7. If Unit or CA/Agreement, Name and/or No.
NNNM1170358. Well Name and No.
CODORNIZ 28 FEDERAL 2 ✓9. API Well No.
30-025-3619610. Field and Pool or Exploratory Area
MORROW11. County or Parish, State
LEA COUNTY, NM

CHEVRON USA INC IS REQUESTING TO RECOMPLETE THE ABOVE SUBJECT WELL. THE WELL IS IN THE MORROW FORMATION AND WILL NOW BE IN THE DELAWARE FORMATION WITH THE NEW FOLLOWING PROCEDURE:

**Codorniz 28 Federal 2
30-025-36196
Chevron USA Inc
December 07, 2016
Conditions of Approval**

Proposed WBD

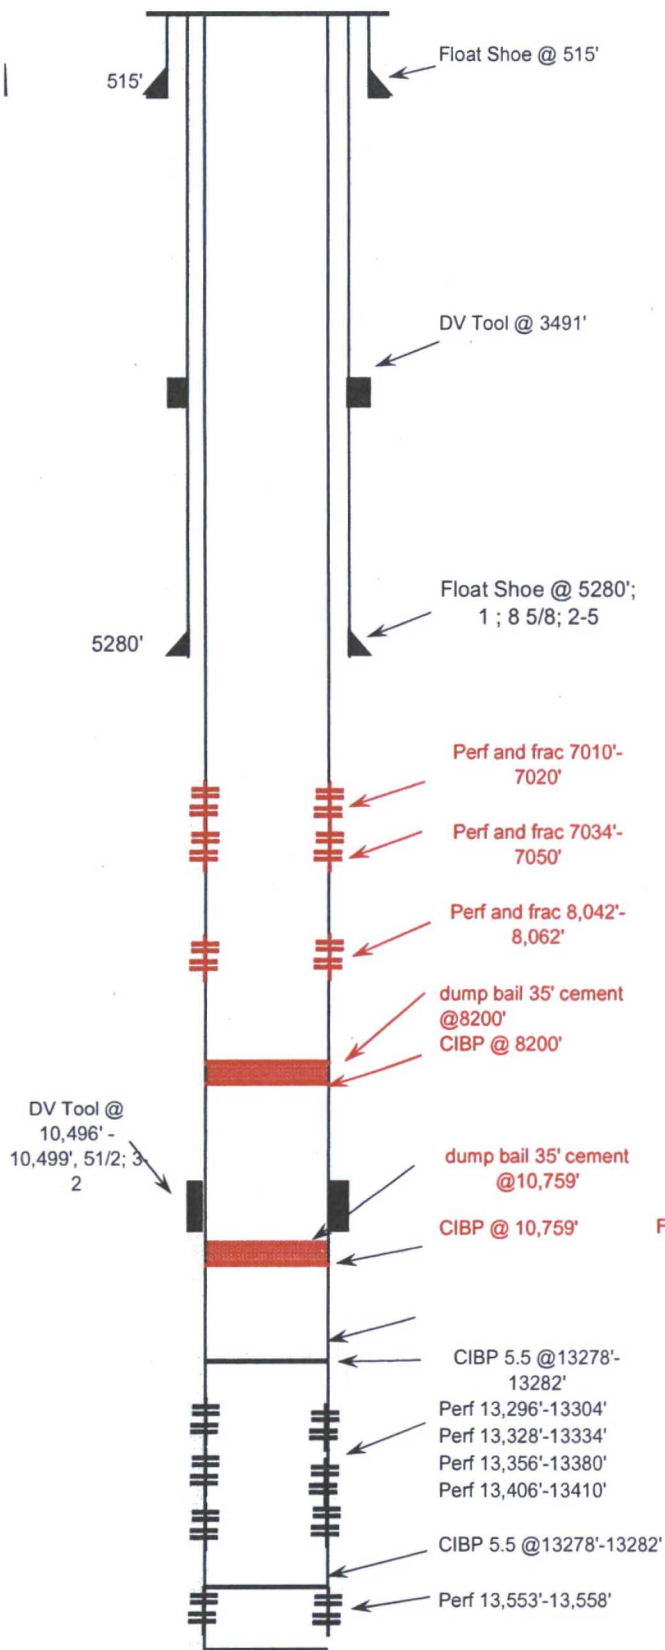
- 1. Operator shall tag CIBP at 13,278' and place 25sx Class H Cement on top. WOC and tag.**
- 2. Operator shall place a solid Class H Cement plug from 12,890'-12,660' to seal the top of the Morrow formation.**

Note: Operator may combine plug 1 and 2. Setting CIBP at 13,278' and cementing to 12,660' if desired. WOC and tag.

- 3. Operator shall place a solid Class H Cement plug from 10,859'-10,651' to seal the top of the Wolfcamp formation.**
- 4. Operator shall place a solid Class H Cement plug from 10,596'-10,396' to seal the DV tool. WOC and tag.**

Note: Operator may combine plug 2 and 3 to place one Class H Cement plug from 10,859'-10,396'. WOC and tag.

- 5. Operator shall place a solid Class H Cement plug from 8,251-8,071' to seal the top of the Bone Spring formation.**
- 6. Must conduct a casing integrity test before perforating and fracturing. Submit results to BLM. The CIT is to be performed on the production casing to max treating pressure. Notify BLM if test fails**
- 7. Before casing or a liner is added or replaced, prior BLM approval of the design is required. Use notice of intent Form 3160-5.**
- 8. Surface disturbance beyond the originally approved pad must have prior approval.**
- 9. Closed loop system required.**
